RSB 589
November 17, 2022

NHTSA #22V 749
TC #2022-571

RECALL SERVICE BULLETIN

Work Instructions for Bulletin 589 :: Replacing an Incorrect Super Star Tire Label

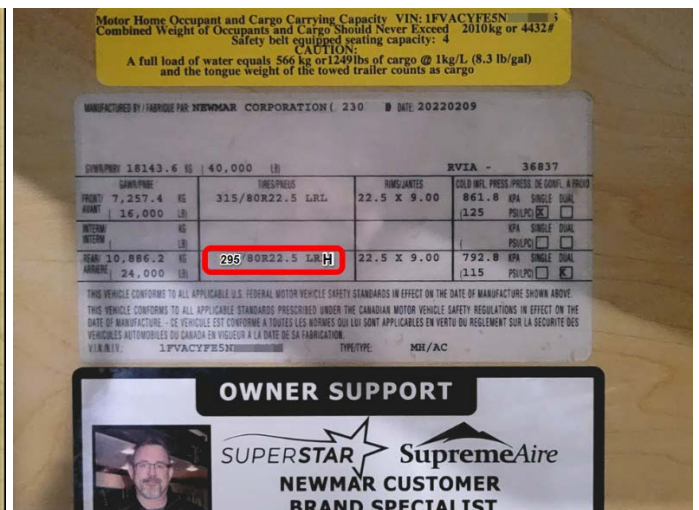
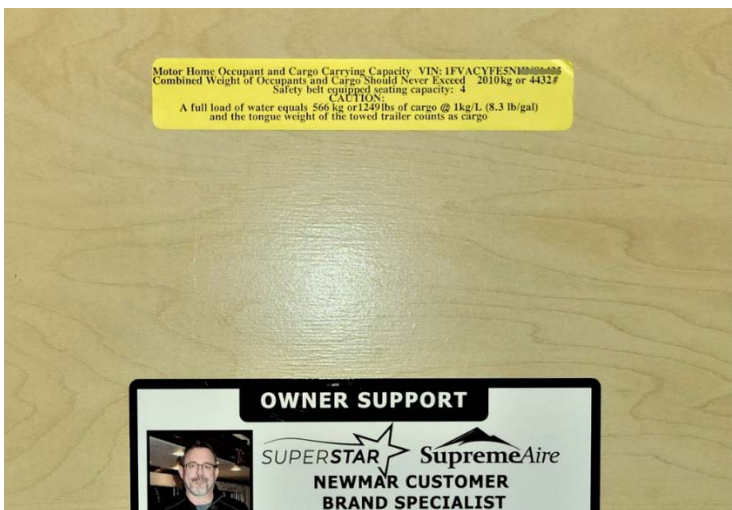
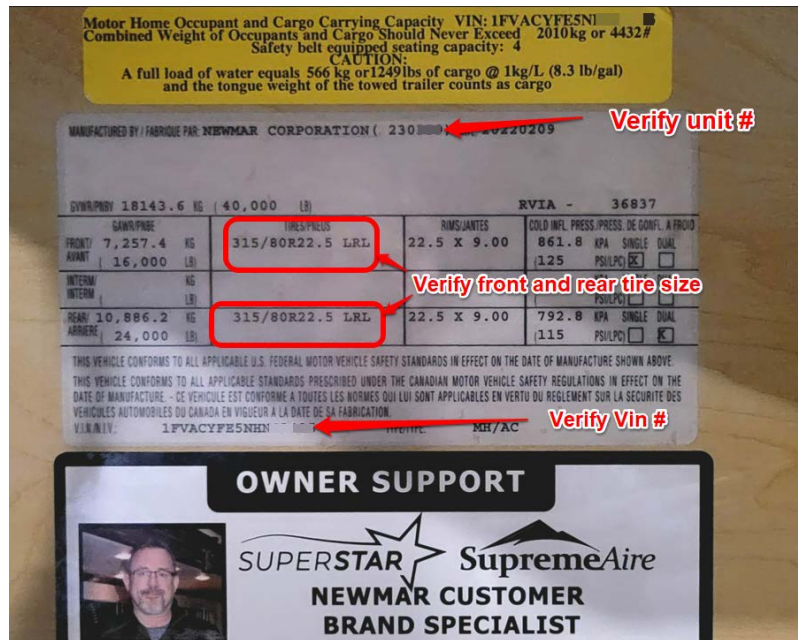
Newmar has identified a discrepancy with the tire size listed on the printed label located in the cabinet above the driver door of select 2020-2022 Super Star Super C coaches. The label with the incorrect tire size does not conform to FMVSS standards and requires replacement.

If correct, proceed with the following instructions to change the label since the rear tire size was printed incorrectly (the original label read "315/80R22.5 LRL" for the rear tire and should have read "295/80R22.5 LRH").

1. Locate the tire label installed inside the cabinet above the driver's door.
2. Starting at one corner, carefully peel off the old label with the rear tire size listed as "315/80R22.5LRL," and discard it.
3. Peel the backing away from the new label. Then apply the new label with the rear tire size listed as "295/80R22.5 LRH" in the same location.
